**TITLE** : Changed outlet stop (flapper) grinder

**MODEL** : Sprso all models

**NUMBER** : SI250311

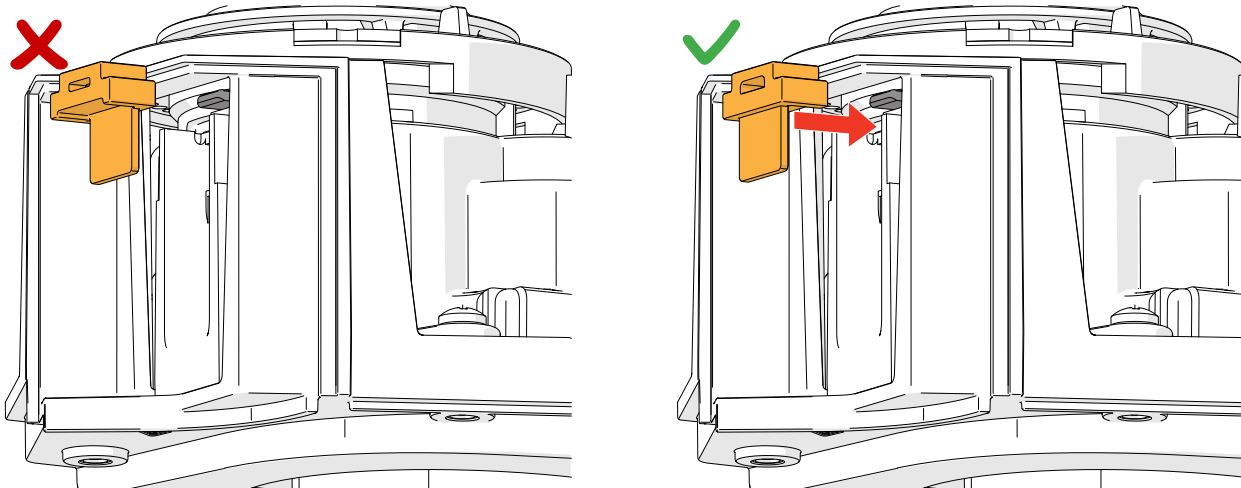
We have changed the outlet stop grinder because in some situation the outlet stop was creating too much friction inside the grinder which resulted in more wear than normal. In some cases the grinder would not grind any coffee anymore.

The modification of the flapper is recognizable as shown in the pictures below.

The outlet stop grinder has changed a bit so that it can be placed in a different orientation, see the below picture for the correct orientation.

► First machine serial number with the modified outlet stop (flapper) grinder: **020002549615**
